U.S. Department of the Interior
BUREAU OF LAND MANAGEMENT

Well Name: NE SQ LAKE PREM	Well Location: T16S / R31E / SEC 3 / LOT 23 / 32.9450011 / -103.8553887	County or Parish/State: EDDY / NM
Well Number: 6	Type of Well: OIL WELL	Allottee or Tribe Name:
Lease Number: NMNM04421	Unit or CA Name:	Unit or CA Number:
US Well Number: 3001504792	Operator: TRIGG OIL AND GAS

Notice of Intent

Type of Action: Plug and Abandonment

PROPOSED PLUGS

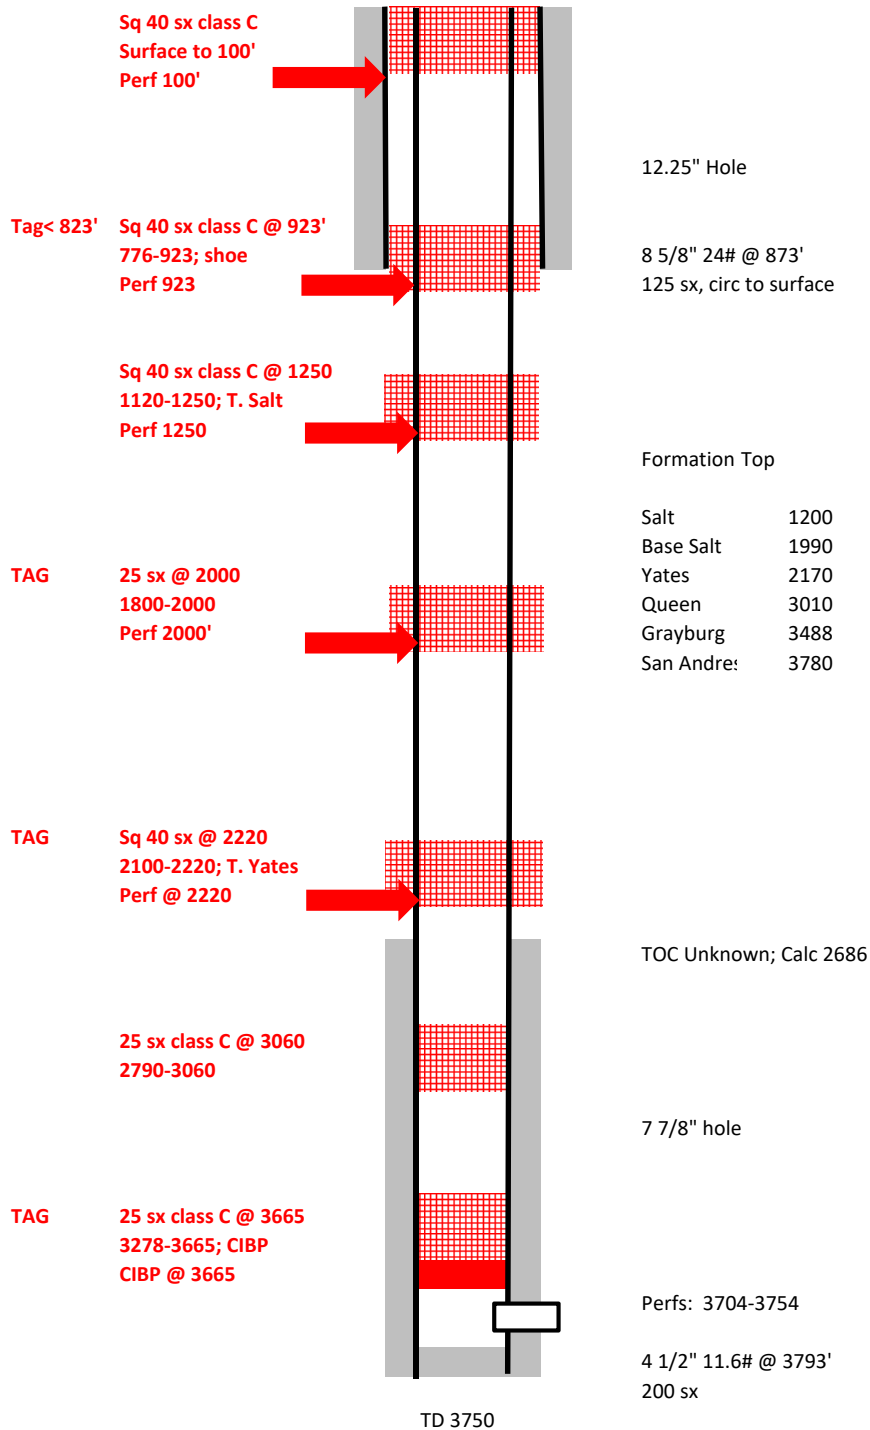
Created By	Condition	Condition Date
loren.diede	Notify the OCD inspection supervisor via email 24 hours prior to beginning Plug & Abandon (P&A) operations.	9/22/2025
loren.diede	Submit CBL tif file to NMOCD for upload into the Well Log File.	9/22/2025
loren.diede	This well is within the LPCH restricted area and a below-ground marker will be required.	9/22/2025
loren.diede	Submit photo and GPS coordinates of the P&A marker with the final P&A reports. The API# on the marker is to be clearly legible.	9/22/2025
loren.diede	Note that the T Salt plug depths contain an error on the written procedure page. the correct depth should be 1250' to 1120'.	9/22/2025

1. MIRU, RIH with bit and scraper.
2. Set CIBP at 3665'. Pressure Test.
3. Run CBL and contact BLM.
4. Spot 25sx from 3665'-3278'. **WOC and Tag. (T/San Andres)**
5. Spot Cl C cmt from 3060'-2790'. (T/Queen)
6. Perf and Sqz Cl C from 2220-2100'. **WOC and Tag (T/Yates)**
7. Perf and Sqz Cl C from 2000' – 1800'. **WOC and Tag (B/Salt)**
8. Perf and Sqz 40 sx Cl C from 1250-1102'. WOC and Tag (T/Salt)
9. Perf and Sqz 40 sx Cl C from 923'-776'. WOC and Tag (Surf. Shoe)
10. Perf and Sqz 40 sx Cl C from 100 to surface.
